NOTICE OF APPROVAL

Planning Case #: Design Study 23255

Project Description: Approval of Design Study, DS 23-255 (Christensen), authorizes an amendment to a previously approved Design Study, DS 20-082, for the replacement of seven (7) existing wood framed windows and replacement of one (1) window with a new sliding glass door on the historic "Harry Turner Jr. House". The project maintains an active building permit (BP 20-336) and is located at on Torres 3 southeast of 1st Avenue in the Single Family (R-1) Zone District and shall be constructed consistent with the application materials dated prepared by Samuel Pitnick dated approved by the Community Planning and Building Department on February 20, 2024 as well as the Phase II Historic Evaluation prepared by Margret Clovis dated February 2, 2024, on file in the Community Planning & Building Department, unless modified by the conditions of approval .

Phase Two Report for the Harry Turner House (APN 010-101-017) Carmel-by-the-Sea, CA.

2 PROPOSED SOUTH ELEVATION
SCALE: 1/4"=1'-0"

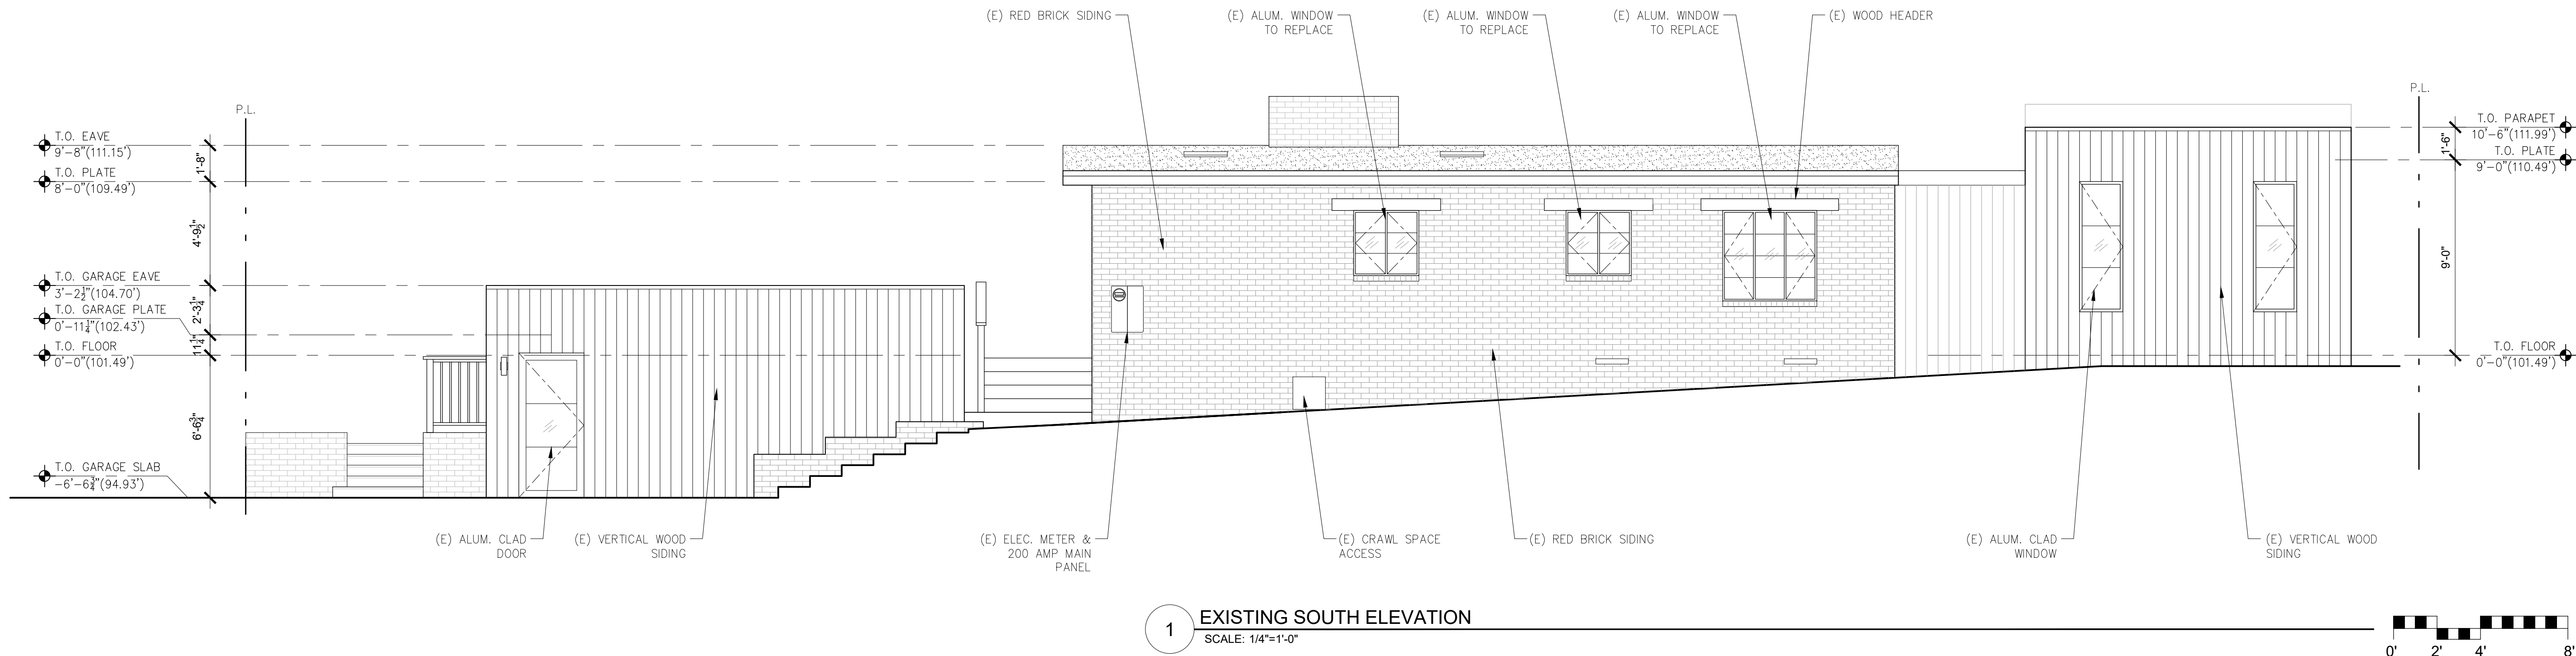
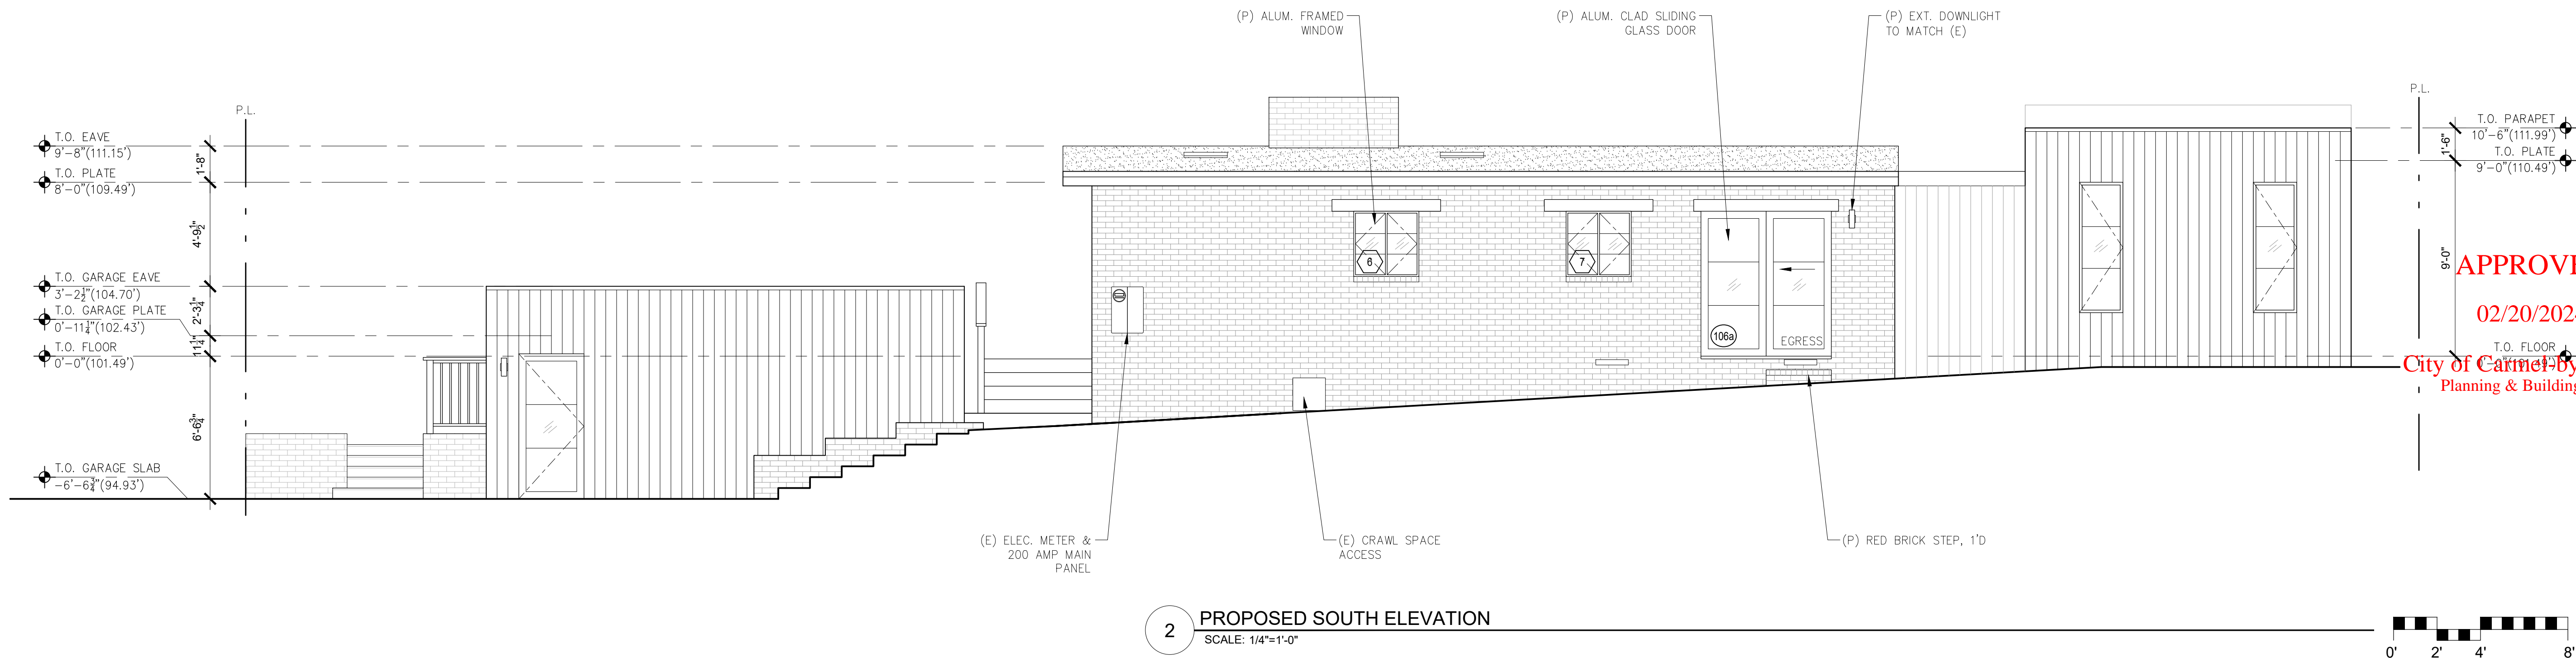
The proposed sliding glass door will be an aluminum clad door from Kolbe. Per Plan Sheet A3.1, it appears that the new sliding glass door on the south elevation will be simple in design, unobtrusive, and it will not appear historic, per the recommendations found in ITS Bulletin 22. However, a cut sheet for the sliding glass door should be included in the plans in order to confirm its suitability for the project. In addition, rather than having a single brick step to the door it is recommended to enlarge the step so it will be the width of the window (see plan sheet A3.1). If the cut sheet confirms that the proposed sliding glass door is appropriate, then the proposed work will be consistent with Standard Nine.

9.	Consistency with Secretary's Standards. <ol style="list-style-type: none"> 1) Required: Prior to Building Permit issuance, the applicant shall revise the project plans to include the cut sheet(s) for the sliding glass door so that their suitability can be confirmed (refer to associated Phase II Evaluation; Standard #9). 2) Recommended: It is recommended the width of the landing adjacent to the new sliding door be widened to the full width of the new door. If widened, a commensurate amount of (permeable or impermeable, as appropriate) site coverage shall be elsewhere on the site. The location of the removed site coverage shall be clearly identified on the site plan and the project data table revised accordingly (refer to associated Phase II Evaluation; Standard #9).
